CITY OF BELLE ISLE PLANNING AND ZONING BOARD REGULAR SESSION

ITEM 3 MEMORANDUM

Public Hearing Case #2017-07- 023 - Proposed Development Site Plan. Pursuant to Belle Isle Code Sec. 54-79 (f) (4), the Board shall review and take action on the proposed site plan, submitted by Thirumala Property's, LLC c/o American Civil Engineering, Co. for a proposed commercial development at 2635 McCoy Road, Belle Isle FL 32809, also known as Parcel #30-23- 30-0000- 00-005. (Continued from the August 22, 2017 meeting)

Site Plan Review: 2635 McCoy Road

OFFICIAL ZONING
OF
THE CITY OF BELLEVILLE

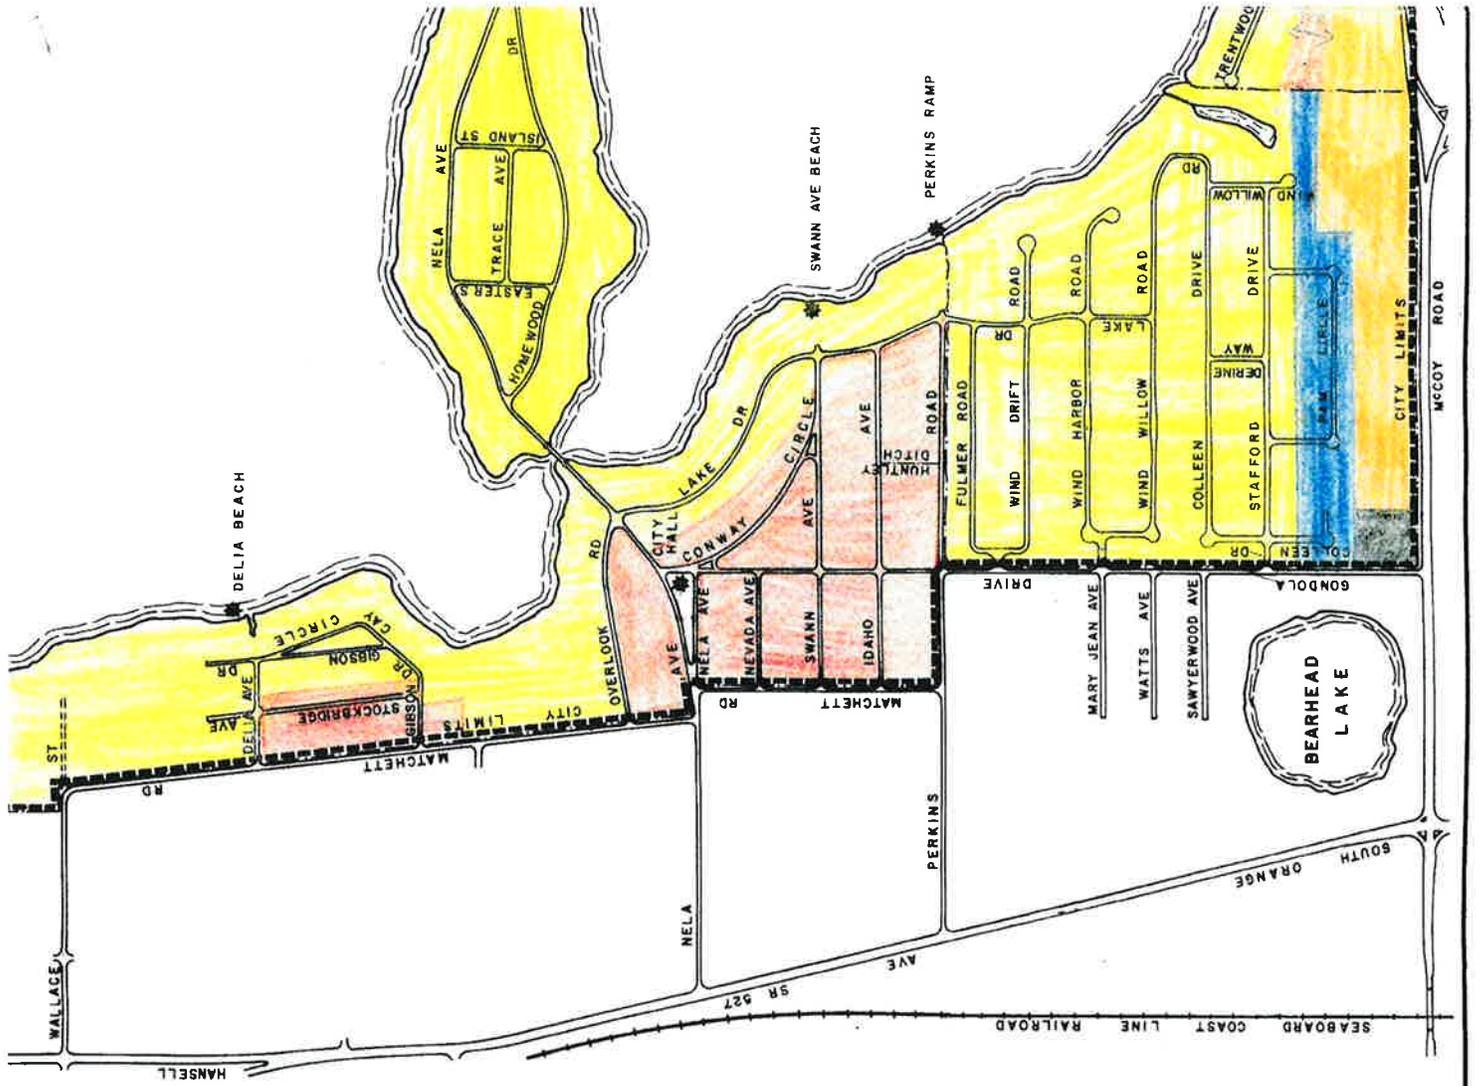
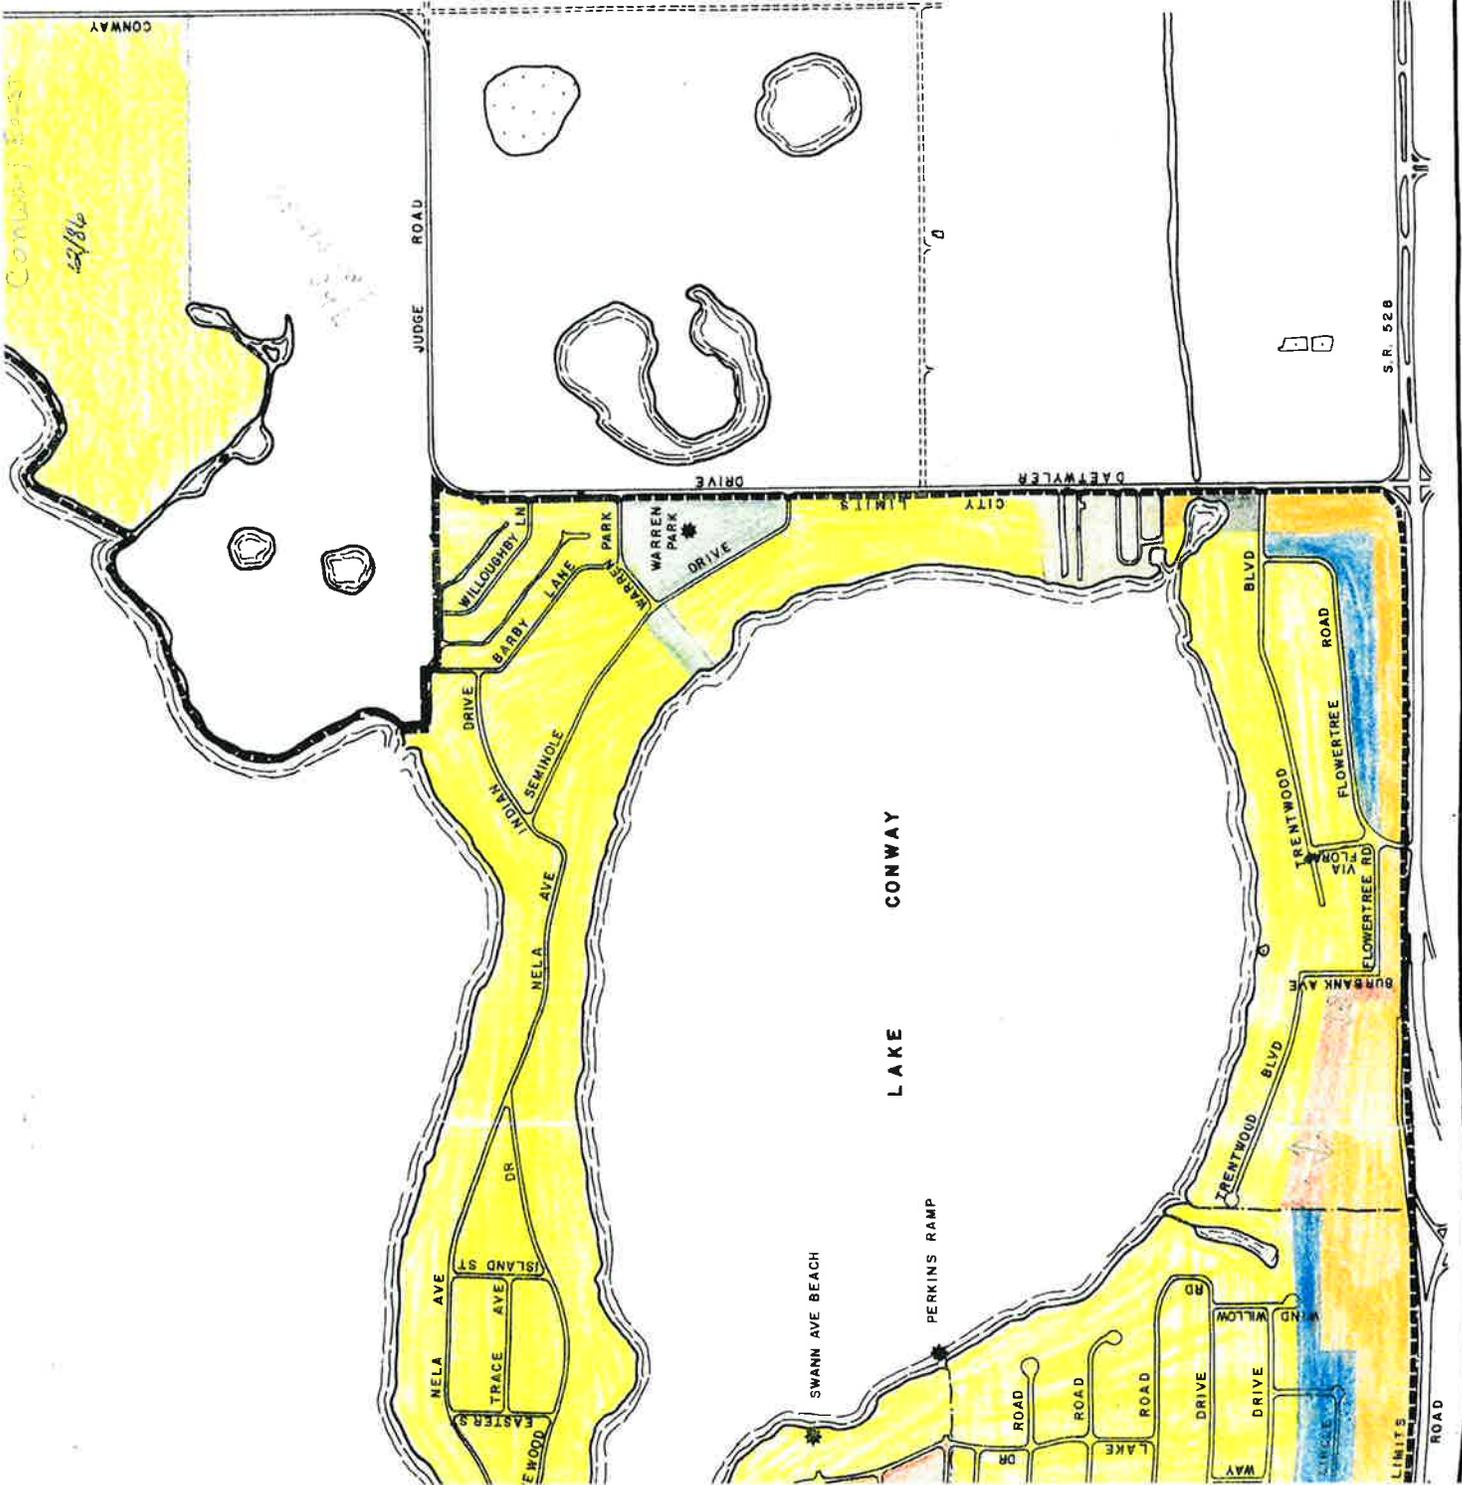
1. The Official Zoning Map of June 30, 1975 shows the portion of the property West of Burbank Avenue and North of the southern line of Flowertree Road zoned R-1 residential and the portion of the property West of Burbank Avenue and South of the southern line of Flowertree Road zoned C-1 commercial.
2. The Zoning Map of 1980 identifies that the Northern 150 feet (possibly wider on the western portion but the width noted is not legible) of the subject property is zoned R-1-A,

7 MCCOY/TRENTWOOD SITE

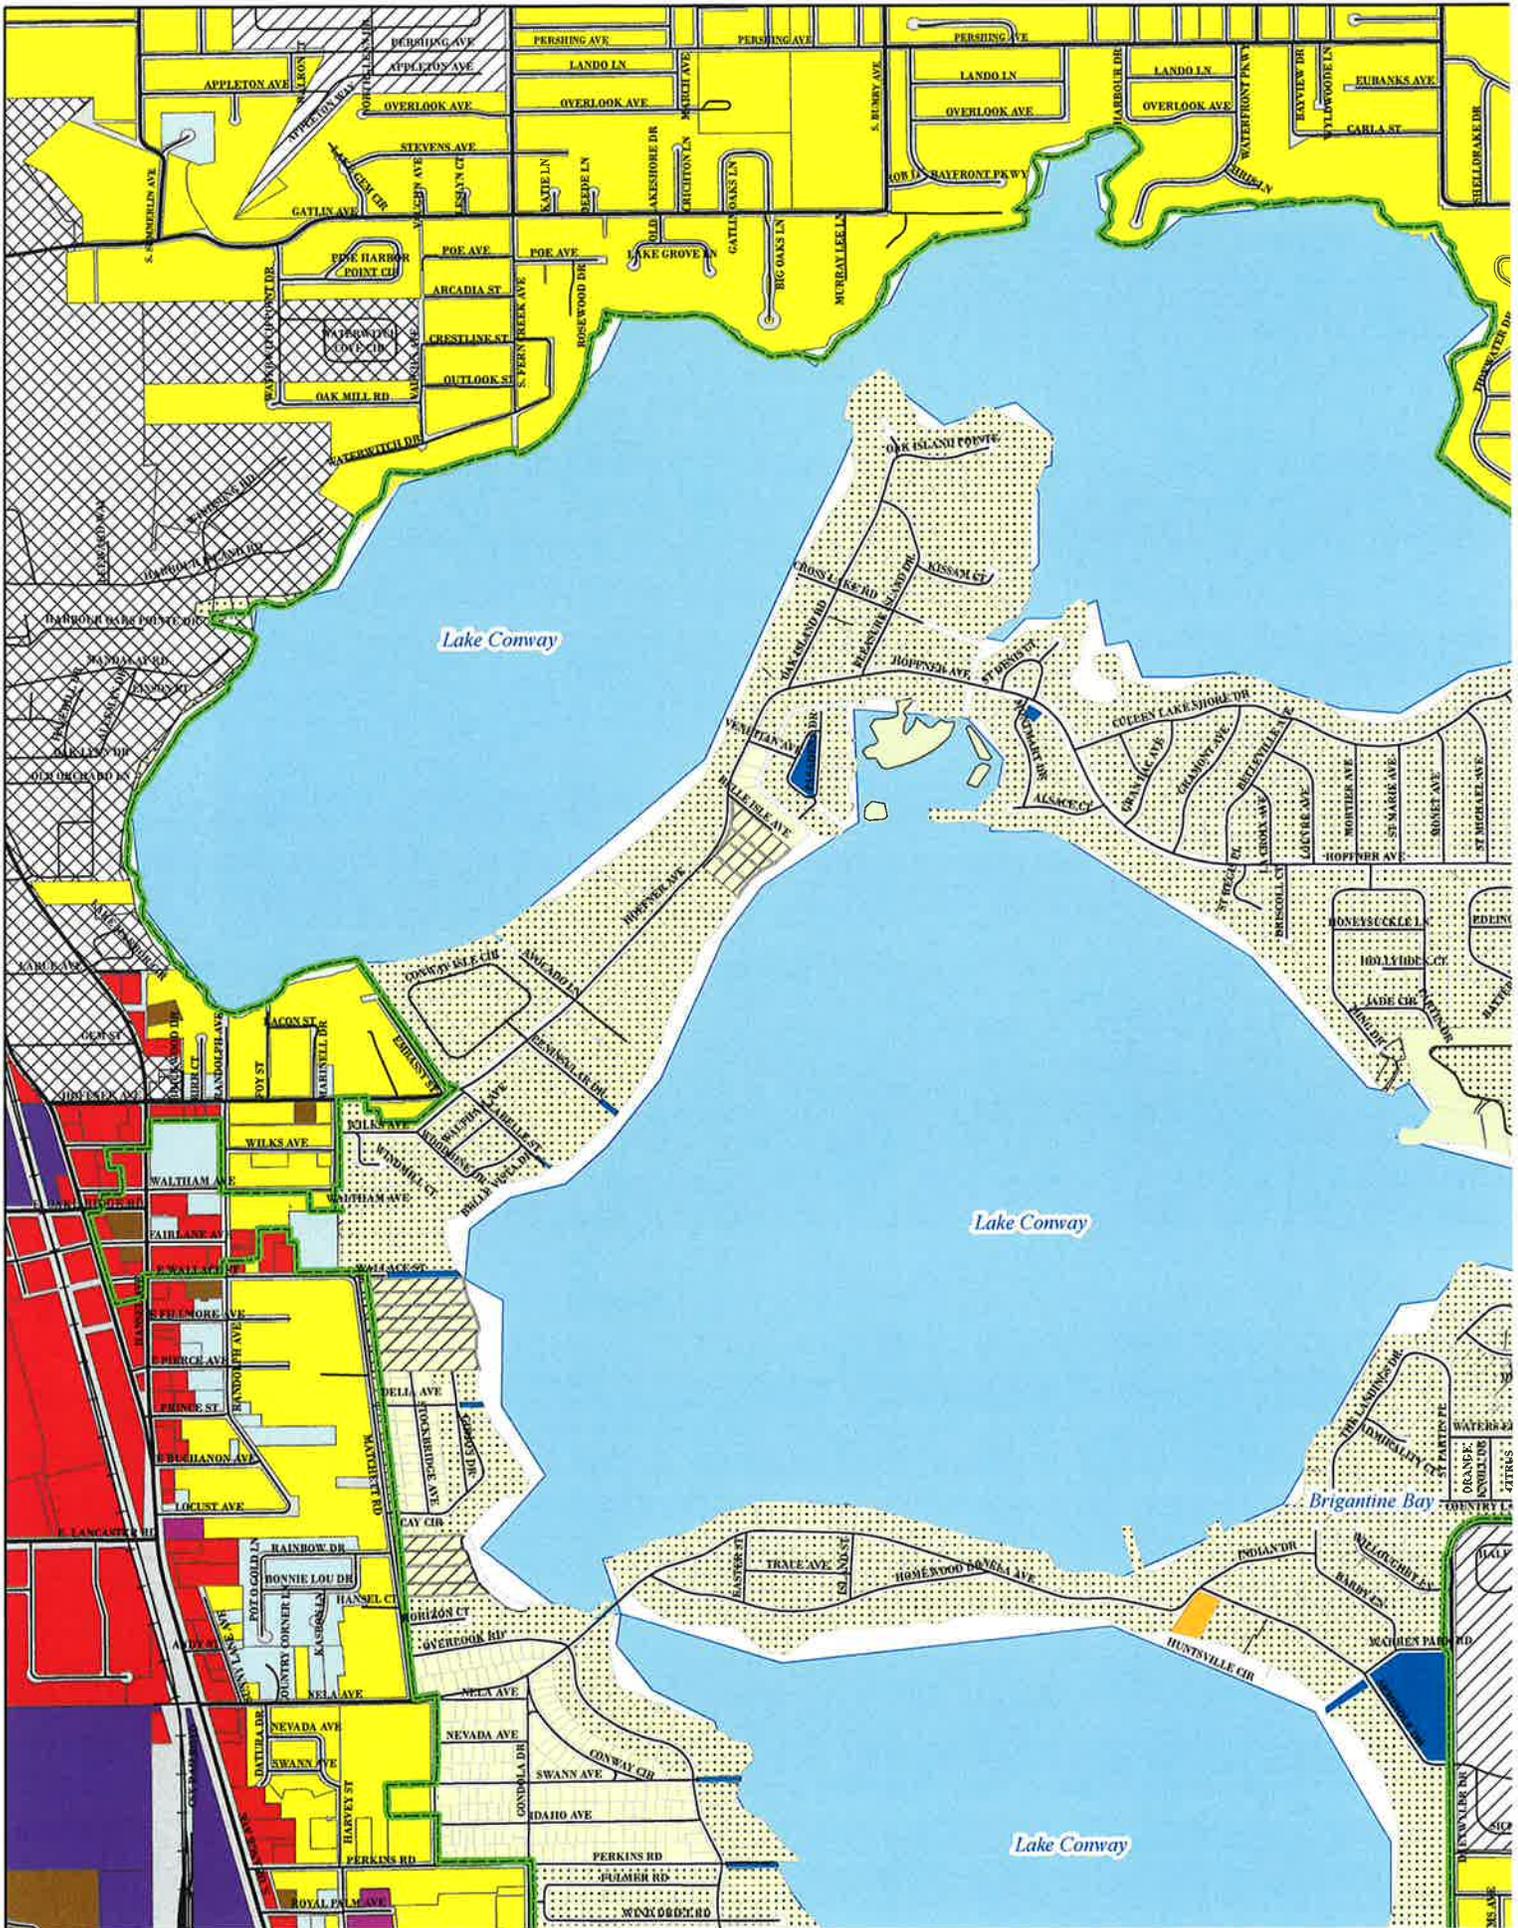
3. The transmittal copy of the December 6, 1990 Comprehensive Plan identifies the northern quarter of the property as low density residential and the southern three-quarters as commercial.

SITE DEVELOPMENT PLAN

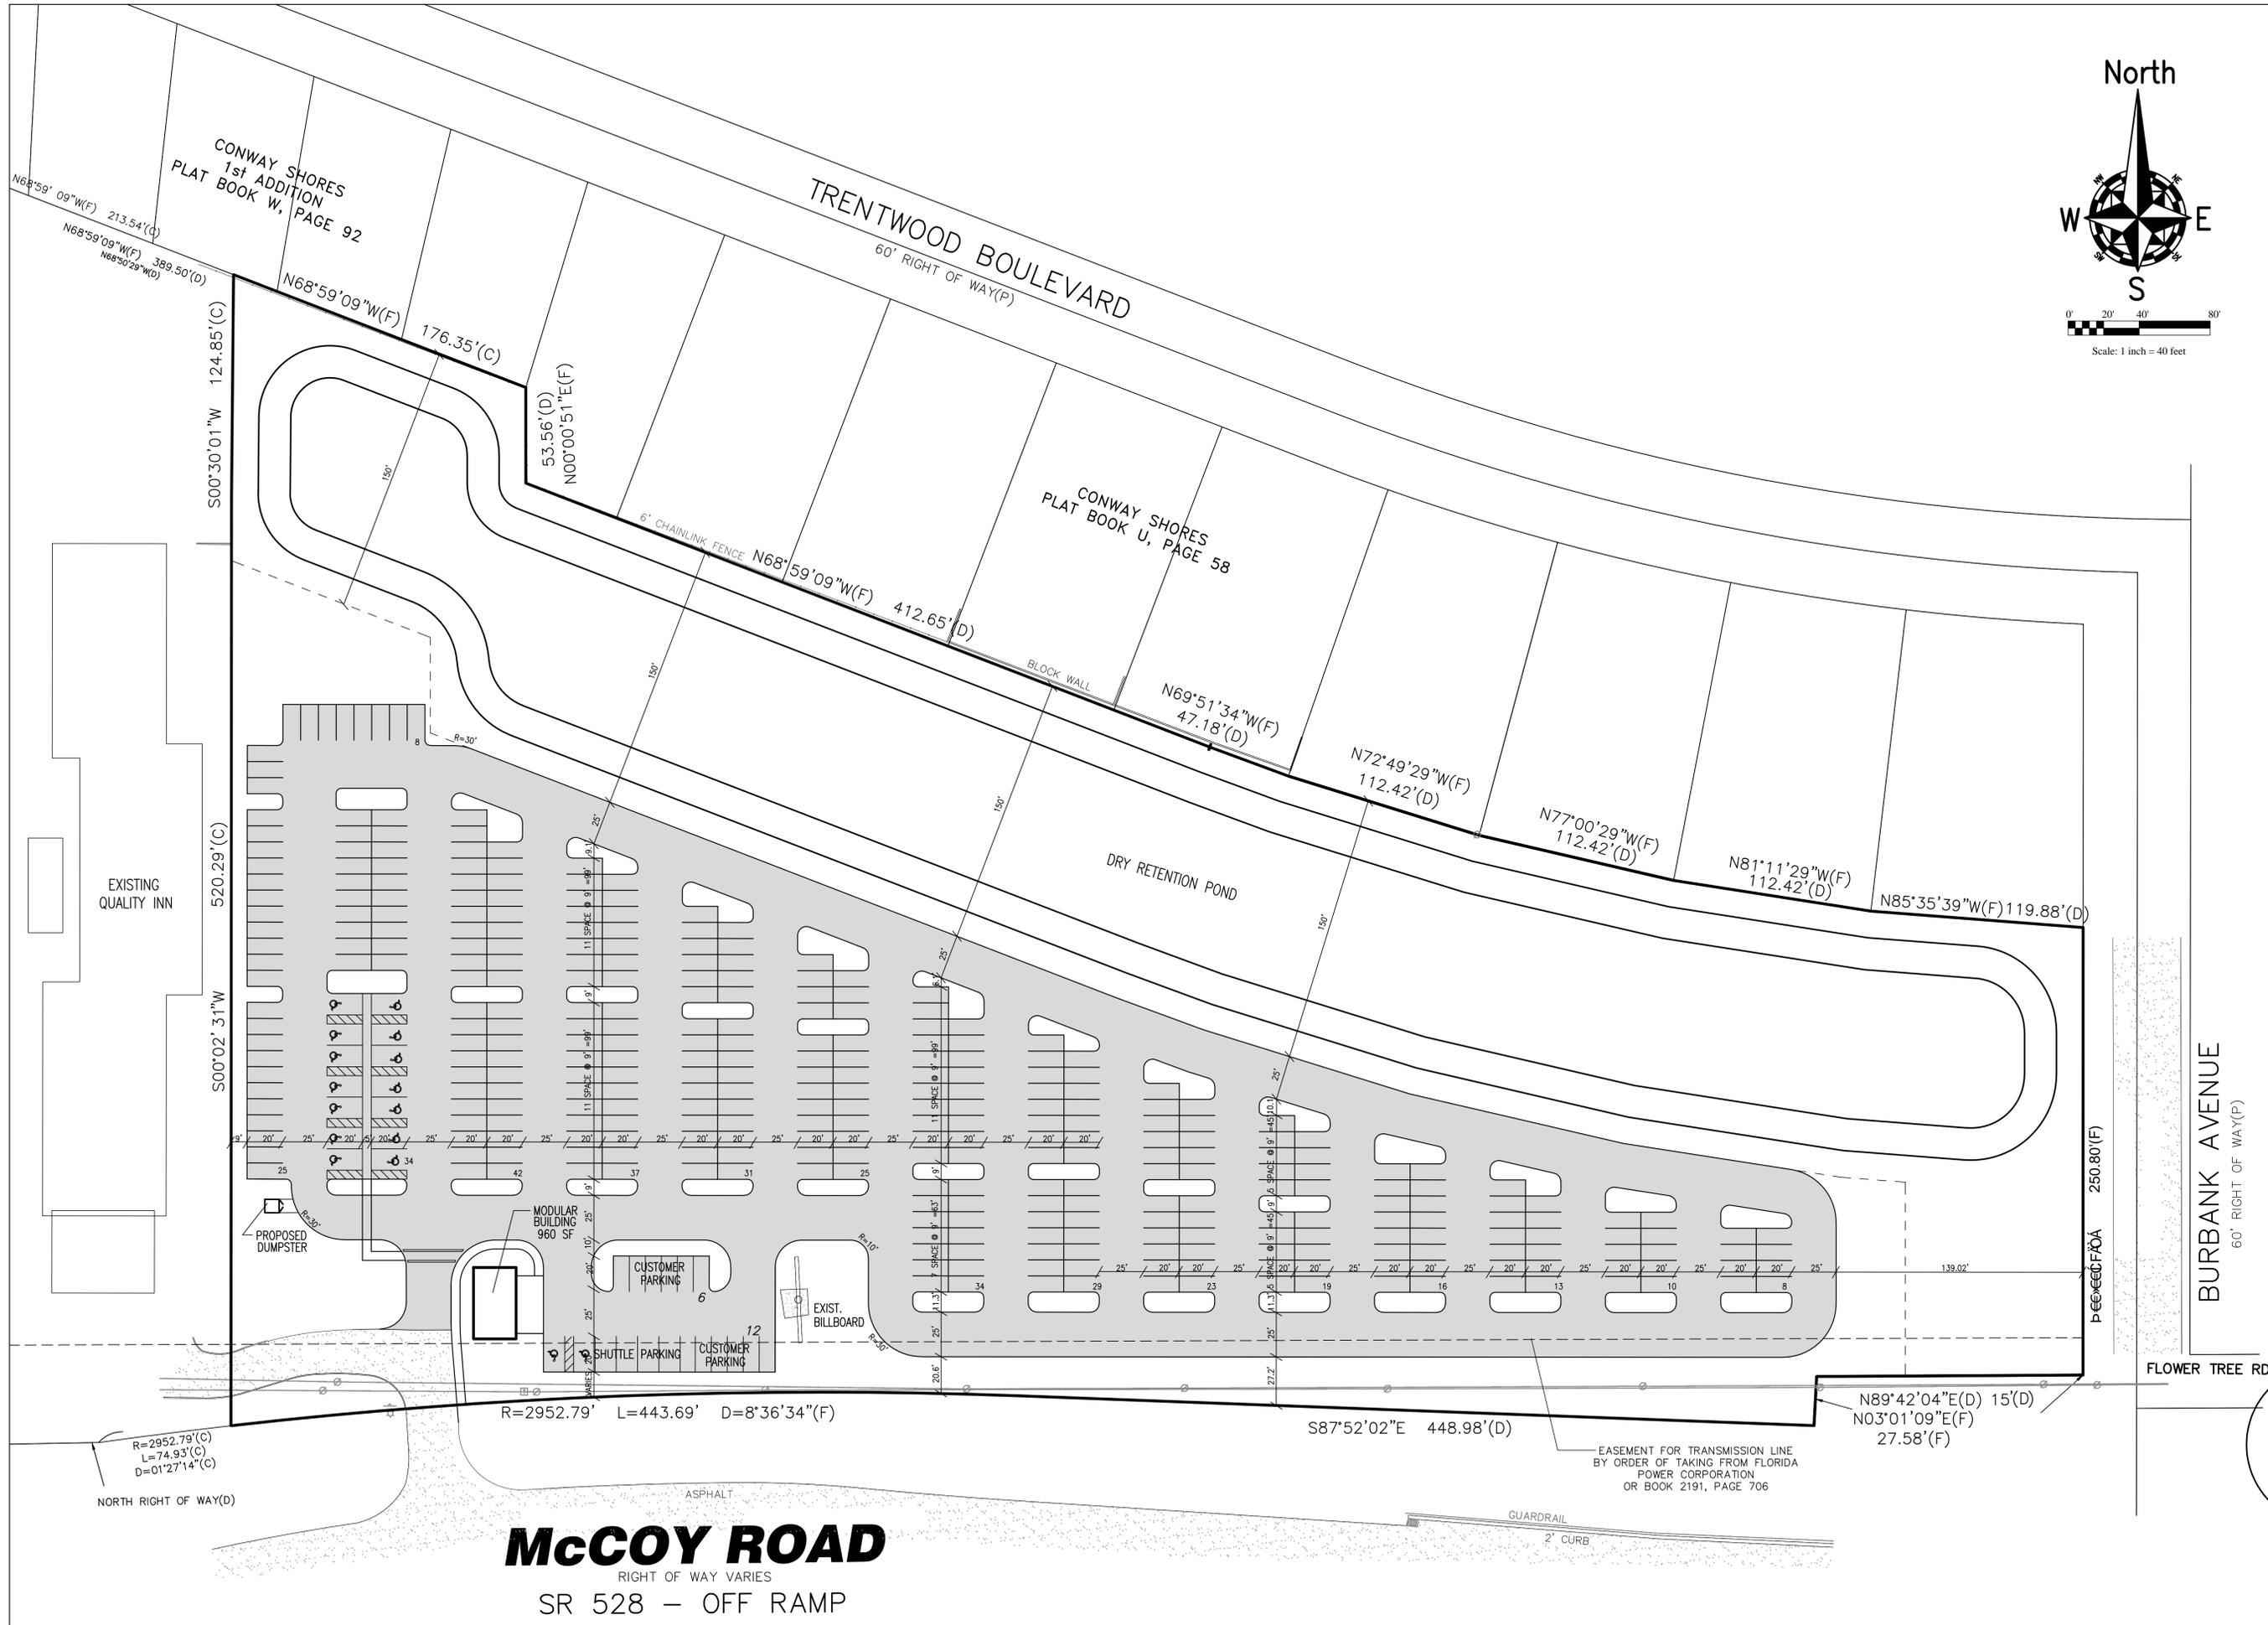
3. A dumpster permit shall be required as part of the building permit process. Please show the proposed location on the development plan.
4. An 8-foot high masonry wall with a 15-foot wide transitional buffer is required adjacent to residentially zoned properties. The buffer must include the following plant material per 100 linear feet: 3 canopy trees; 4 understory trees; and, 15 shrubs. The owner must execute a recordable document which requires construction and maintenance of the wall in good repair. The plan needs to be revised to correct the buffer width discrepancies where they call out a five-foot or fifteen-foot width in the specified east, south, and west boundary locations on Sheet 3 of 9.
